PRODUCT CHANGE NOTIFICATION (PCN)

A-MCSP-80300 MODULAR CABLE

CHANGE NOTIFICATION: PCN 20220425_A-MCSP-80300

DESCRIPTION OF CHANGES: CHANGE OF DATA SHEET
CHANGE OF DATA SHEET
New Draw.-No. ASS_0841_CAreV01

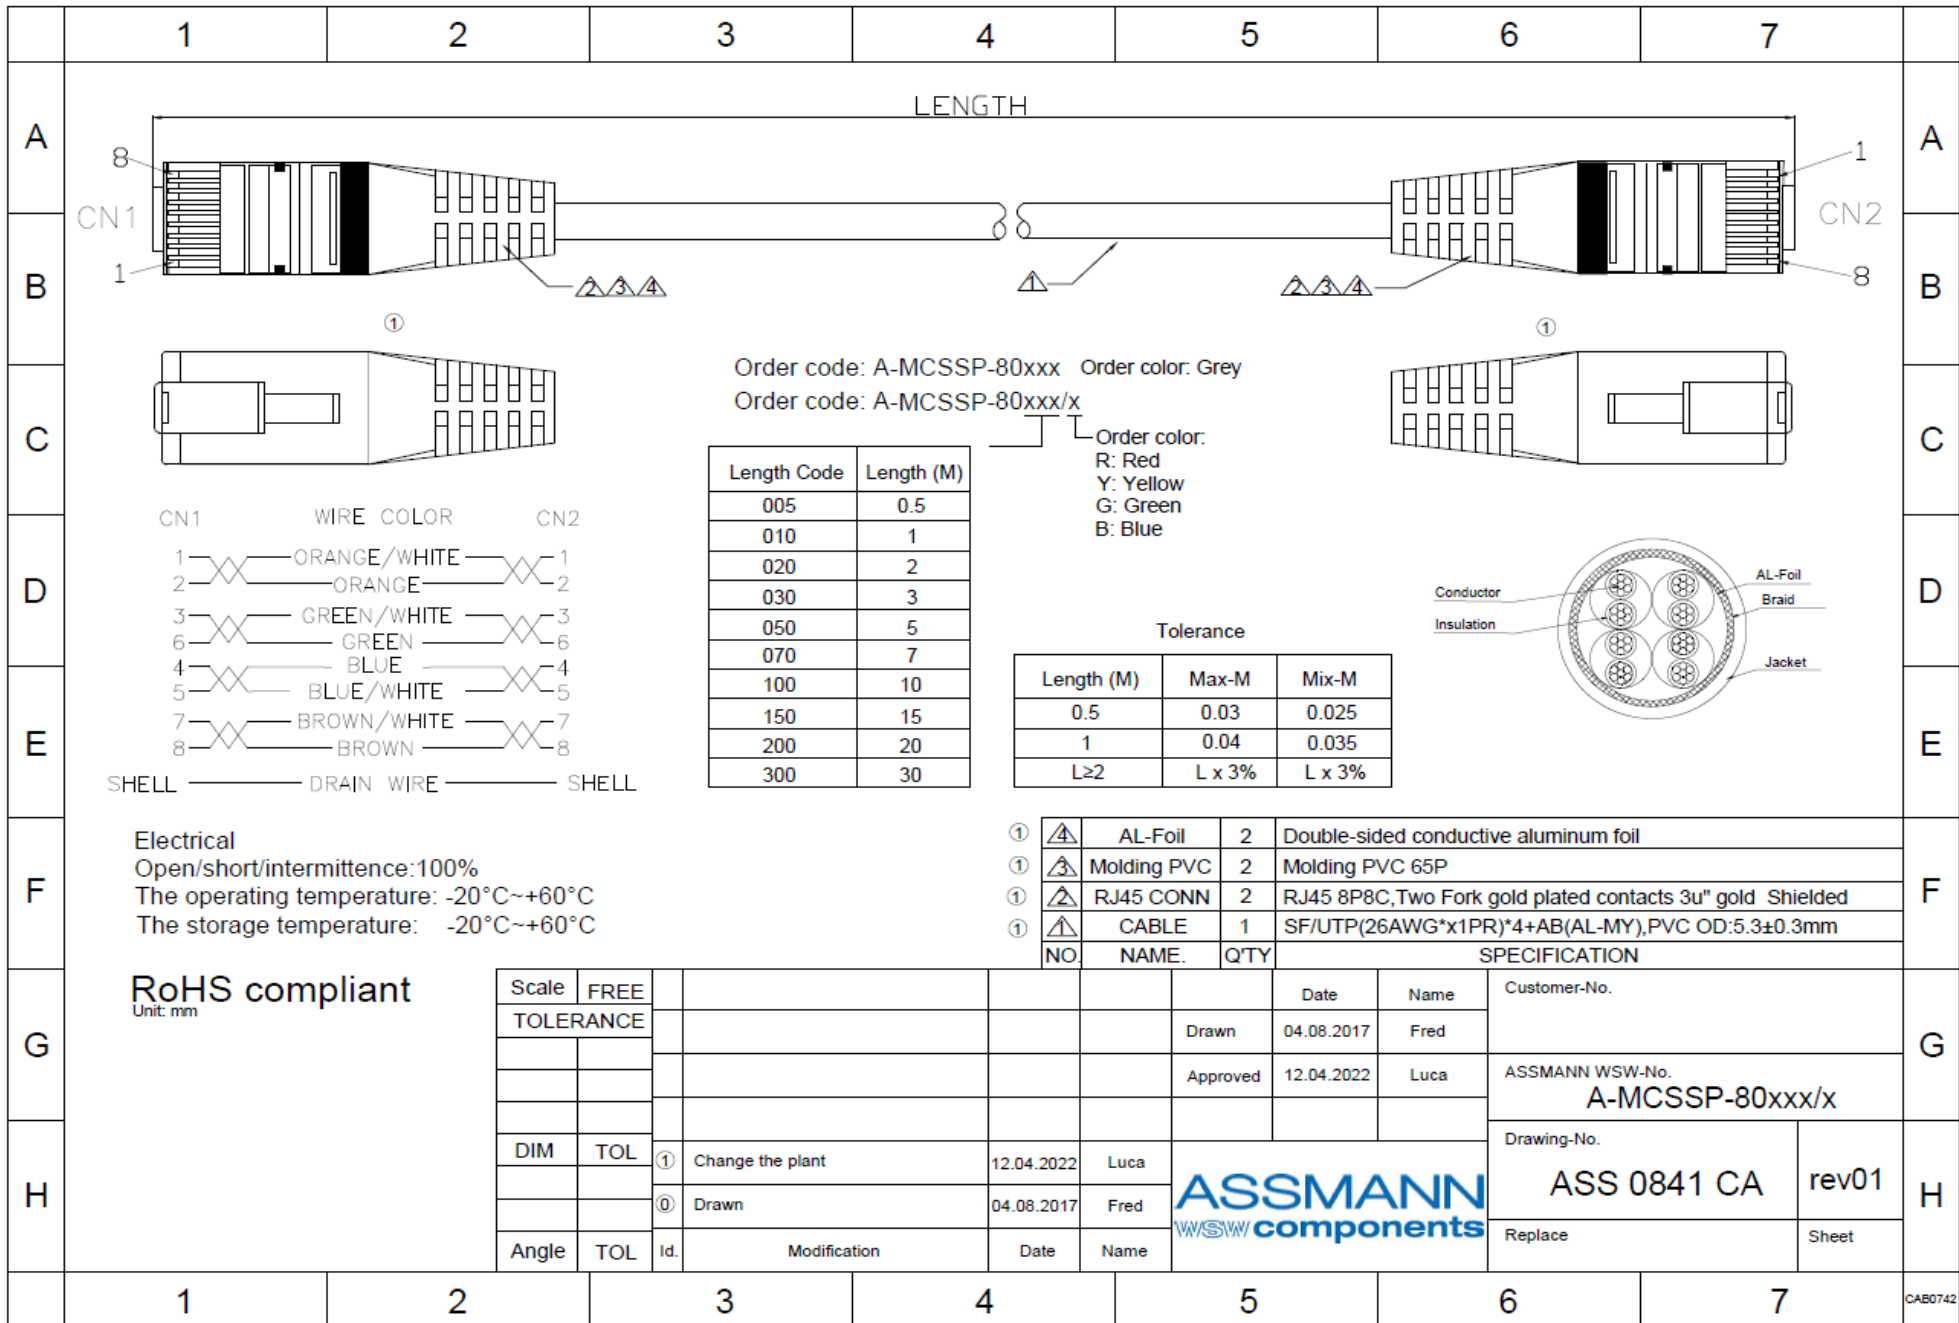
A-MCSP-80300	OLD VERSION	A-MCSP-80300	NEW VERSION																																				
<p>Appearance</p>		<p>Appearance</p>																																					
<p>BOM</p> <table border="1"> <thead> <tr> <th>NO.</th> <th>NAME</th> <th>Q'TY</th> <th>SPECIFICATION</th> </tr> </thead> <tbody> <tr> <td>③</td> <td>Molding PVC</td> <td>2</td> <td>Molding PVC 45P</td> </tr> <tr> <td>②</td> <td>RJ45 CONN</td> <td>2</td> <td>RJ45 8P8C,Two Fork gold plated contacts 3u" gold</td> </tr> <tr> <td>①</td> <td>CABLE</td> <td>1</td> <td>SFTP(26AWG*x1PR)*4+AB,PVC OD:5.3±0.3mm</td> </tr> </tbody> </table>		NO.	NAME	Q'TY	SPECIFICATION	③	Molding PVC	2	Molding PVC 45P	②	RJ45 CONN	2	RJ45 8P8C,Two Fork gold plated contacts 3u" gold	①	CABLE	1	SFTP(26AWG*x1PR)*4+AB,PVC OD:5.3±0.3mm	<p>BOM</p> <table border="1"> <thead> <tr> <th>NO.</th> <th>NAME</th> <th>Q'TY</th> <th>SPECIFICATION</th> </tr> </thead> <tbody> <tr> <td>①</td> <td>AL-Foil</td> <td>2</td> <td>Double-sided conductive aluminum foil</td> </tr> <tr> <td>②</td> <td>Molding PVC</td> <td>2</td> <td>Molding PVC 65P</td> </tr> <tr> <td>③</td> <td>RJ45 CONN</td> <td>2</td> <td>RJ45 8P8C,Two Fork gold plated contacts 3u" gold Shielded</td> </tr> <tr> <td>①</td> <td>CABLE</td> <td>1</td> <td>SF/UTP(26AWG*x1PR)*4+AB(AL-MY),PVC OD:5.3±0.3mm</td> </tr> </tbody> </table>		NO.	NAME	Q'TY	SPECIFICATION	①	AL-Foil	2	Double-sided conductive aluminum foil	②	Molding PVC	2	Molding PVC 65P	③	RJ45 CONN	2	RJ45 8P8C,Two Fork gold plated contacts 3u" gold Shielded	①	CABLE	1	SF/UTP(26AWG*x1PR)*4+AB(AL-MY),PVC OD:5.3±0.3mm

NO.	NAME	Q'TY	SPECIFICATION																																				
③	Molding PVC	2	Molding PVC 45P																																				
②	RJ45 CONN	2	RJ45 8P8C,Two Fork gold plated contacts 3u" gold																																				
①	CABLE	1	SFTP(26AWG*x1PR)*4+AB,PVC OD:5.3±0.3mm																																				
NO.	NAME	Q'TY	SPECIFICATION																																				
①	AL-Foil	2	Double-sided conductive aluminum foil																																				
②	Molding PVC	2	Molding PVC 65P																																				
③	RJ45 CONN	2	RJ45 8P8C,Two Fork gold plated contacts 3u" gold Shielded																																				
①	CABLE	1	SF/UTP(26AWG*x1PR)*4+AB(AL-MY),PVC OD:5.3±0.3mm																																				
<p>FOR DETAIL, PLEASE TAKE ATTACHED NEW DRAWING: FOR REFERENCE</p>
